Contract #: 04-0120F4Cty: SF/ALA Rte: 80 PM: 13.2/13.9File #: 69.25B**QUALITY ASSURANCE -- NON-CONFORMANCE REPORT****Location:** Changxing Island, Shanghai, P.R. China**Report No:** NCR-000539**Prime Contractor:** American Bridge/Fluor Enterprises, a JV**Date:** 17-Dec-2009**Submitting Contractor:** Zhenhua Port Machinery Company, Ltd (ZPMC), Changxing Island**NCR #:** ZPMC-0512**Type of problem:**

**Reference Description:** Missed UT Indication by QC, Segment 8BW**Description of Non-Conformance:**

**Subject:** NCR No. ZPMC-0512

Reference Description: Missed UT Indication by QC, Segment 8BW

WELD NUMBER: SSD13A-PP065-128

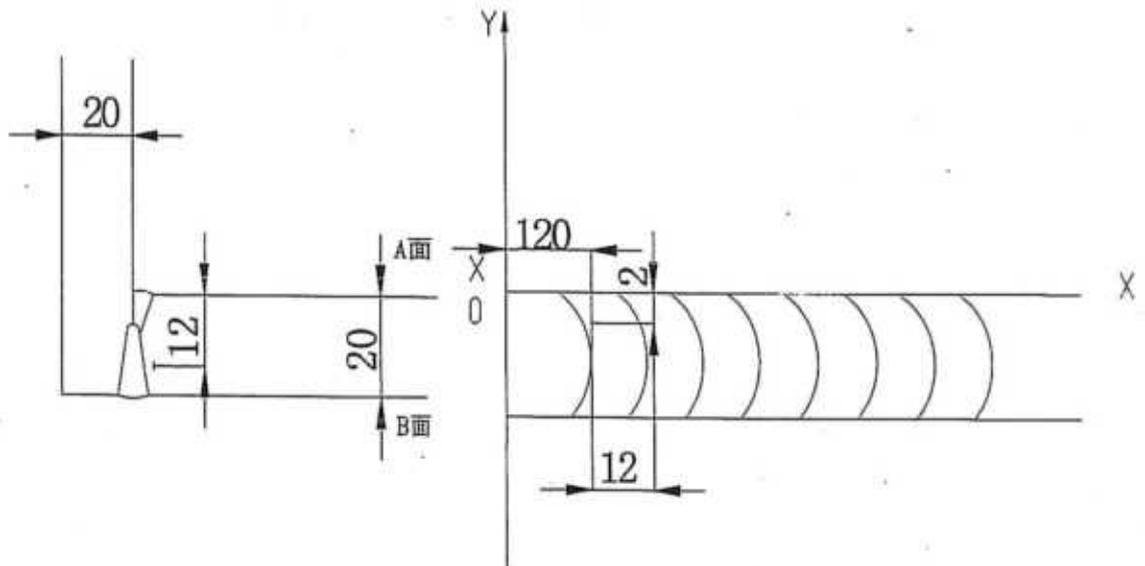
The Caltrans Quality Assurance (QA) Inspector performed 10% verification of Ultrasonic Testing (UT) on the weld between FL2 flange to FL1 located at Segment 8BW panel point 65 (PP65). The QA inspector discovered one (1) class "A" non-conforming indication measuring approximately 12 mm in length.

- The non-conforming UT class "A" indication measured approximately 12mm in length.
- The weld is identified as: SSD13A-PP65-128 at PP65.
- The weld is a Complete Joint Penetration (CJP) Tee Joint.
- The OBG Segment 8BW is located at outside the Paint Shop.
- The Notice of Witness Inspection Number (NWIT) is 004869.
- TL-6027 UT report was written by QA inspector B205 on this date.

Rejected indication found by ultrasonic inspection is less than the maximum allowance aggregate length.

1. Gouge or grind from nearer side from metal edge ( $D \leq 0.65T$ , "D" is depth of defects, "T" is thickness of metal) to remove all defects;

2. Follow repair WPS for joint preparation, preheat, and weld deposit;

3. Verify with VT no defects remain in the weld joint prior to welding;

4. Grind the repaired area flush with base metal or the adjacent weld;

5. Perform UT inspection to the weld along with 50mm on each end of the repair area;

WELD NUMBER: SEG048\*-005

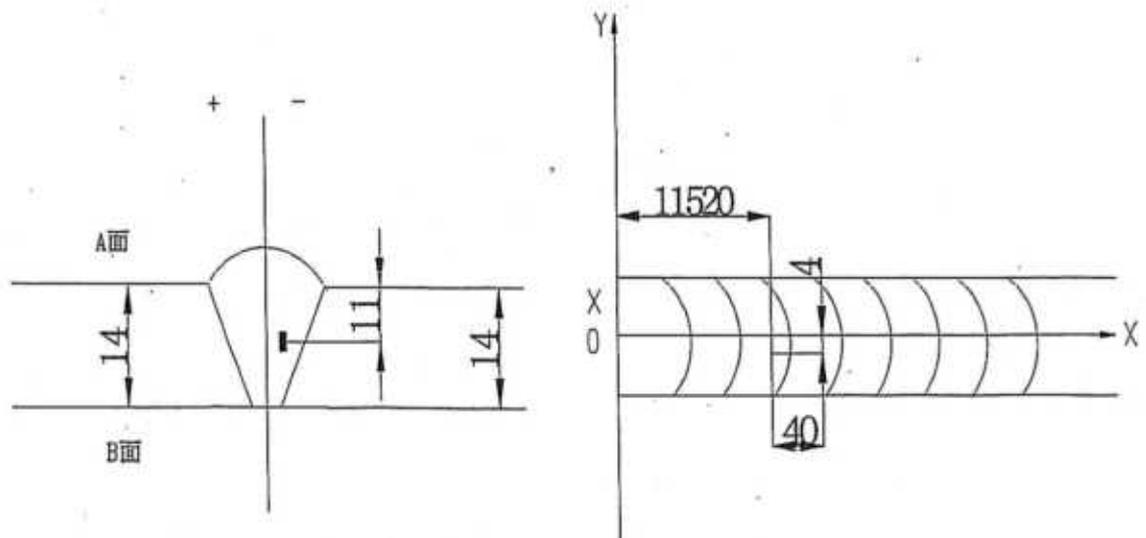
During the Quality Assurance Ultrasonic Testing (UT) review of weld located on Segment 8CE, this Quality Assurance Inspector (QA) discovered the following issue:

-One (1) Class "A" indication measuring approximately 40 mm in length.

-The dB rating is +6.

-The weld is identified as SEG048\*-005.

-The weld is a Complete Joint Penetration (CJP) butt weld joining Deck Plate DP364A to DP337A.

Rejected indication found by ultrasonic inspection is less than the maximum allowance aggregate length.

1. Gouge or grind from nearer side from metal edge ( $D \leq 0.65T$ , "D" is depth of defects, "T" is thickness of metal) to remove all defects;

2. Follow repair WPS for joint preparation, preheat, and weld deposit;

3. Verify with VT no defects remain in the weld joint prior to welding;

4. Grind the repaired area flush with base metal or the adjacent weld;

5. Perform UT inspection to the weld along with 50mm on each end of the repair area;

(UT探伤发现的缺陷总长度小于最大允许长度。) CA053-003

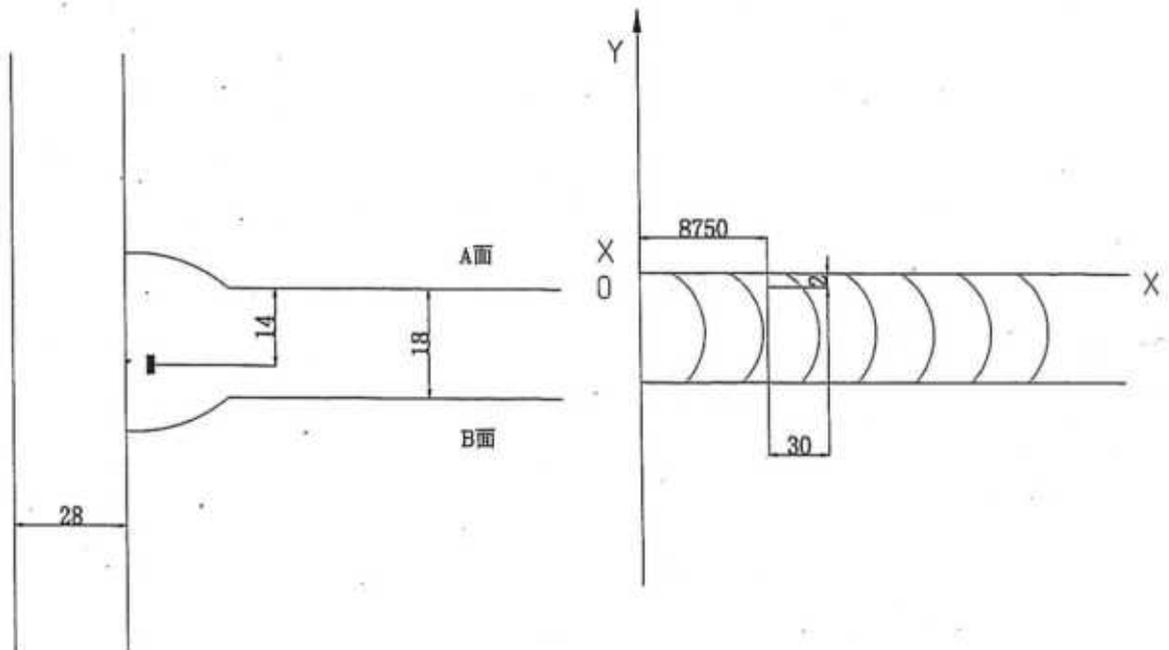
During the Quality Assurance Ultrasonic Testing (UT) review of welds located on Orthotropic Box Girder (OBG) segment 8CW, this Quality Assurance Inspector (QA) discovered the following issues:

- One (1) class "A" longitudinal linear indication measuring approximately 30mm in length.
- The indication dBs rating is a +7.
- Material thickness is 18mm.
- The depth of the indication is approximately 14mm.
- The weld is identified as CA053-003.
- The weld is designated as Seismic Performance Critical Material (SPCM).
- The indication is clearly marked on or near the weld.
- The weld is a Complete Joint Penetration (CJP) corner joint joining Side Plate SP436A (SPCM) to Edge Plate EP64A (SPCM).
- Segment 8CW is located in front of blast bay 1.

Rejected indication found by ultrasonic inspection is less than the maximum allowance aggregate length.

1. 从缺陷距离端面较近一侧 ( $D \leq 0.65T$ , D为缺陷深度, T为板厚) 采用碳刨或打磨的方法去除焊缝缺陷;
  2. 参照返修焊接工艺规程 (WPS) 准备正确的接头型式, 预热和焊接;
  3. 焊前对修补区域进行VT检测保证缺陷完全被消除;
  4. 将修补区域打磨到与母材或邻近焊缝平齐;
  5. 对焊缝进行UT检测, 检测范围为返修区域以及其两端各延长50mm.
- 
1. Gouge or grind from nearer side from metal edge ( $D \leq 0.65T$ , "D" is depth of defects, "T" is thickness of metal) to remove all defects;
  2. Follow repair WPS for joint preparation, preheat, and weld deposit;
  3. Verify with VT no defects remain in the weld joint prior to welding;
  4. Grind the repaired area flush with base metal or the adjacent weld;
  5. Perform UT inspection to the weld along with 50mm on each end of the repair area;

(UT探伤发现的缺陷总长度小于最大允许长度。) SEG047B-012

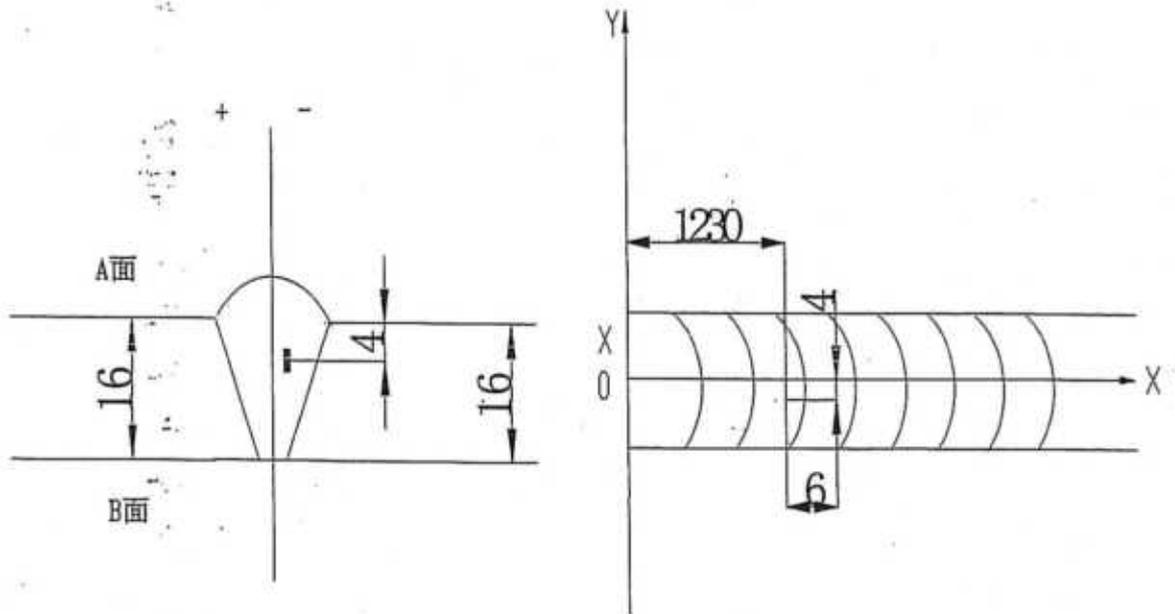
Rejected indication found by ultrasonic inspection is less than the maximum allowance aggregate length.

1. Gouge or grind from nearer side from metal edge ( $D \leq 0.65T$ , "D" is depth of defects, "T" is thickness of metal) to remove all defects;

3. Verify with VT no defects remain in the weld joint prior to welding;

(UT探伤发现的缺陷总长度小于最大允许长度。) SEG047B-013

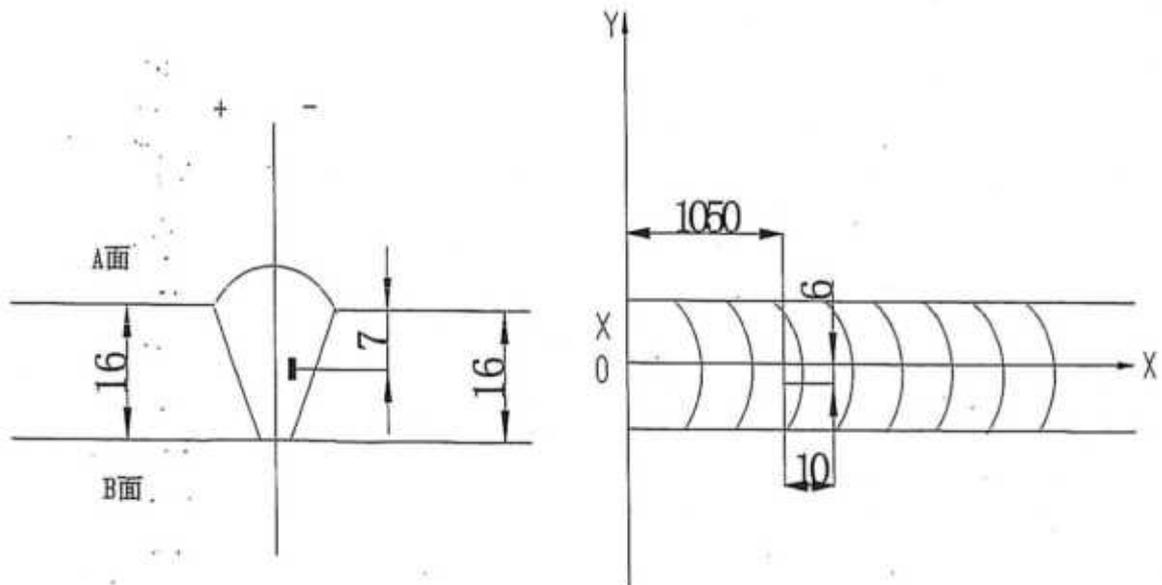
Rejected indication found by ultrasonic inspection is less than the maximum allowance aggregate length.

1. Gouge or grind from nearer side from metal edge ( $D \leq 0.65T$ , "D" is depth of defects, "T" is thickness of metal) to remove all defects;

3. Verify with VT no defects remain in the weld joint prior to welding;
